OVER THE CAMDEN, N. J. SOLDERING IRON MARCH 2, 1937

PREPARED FOR THE INFORMATION AND USE OF RCA VICTOR DISTRIBUTORS' SERVICE MANAGERS

MODELS 5T6, 5T7 and 5T8

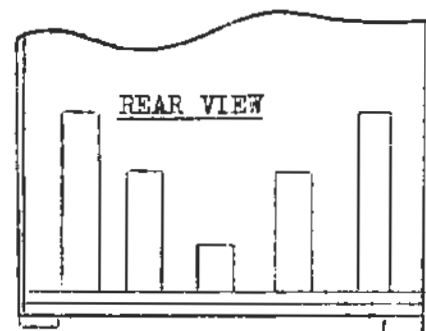
The small black insulated IRC resistor (1.8 ohms) which connects from the "hot" side of the 6F6 heater circuit to the terminal strip directly behind the volume control, should be replaced on all chasses passing through service shops for repair. The replacement resistor, Stock #13820 is a wire wound type, with the resistance element enclosed in a ceramic tube. This resistor is in series with the pilot lamps and serves to reduce voltage. A quantity of the replacement resistors should be stocked for the above purpose.
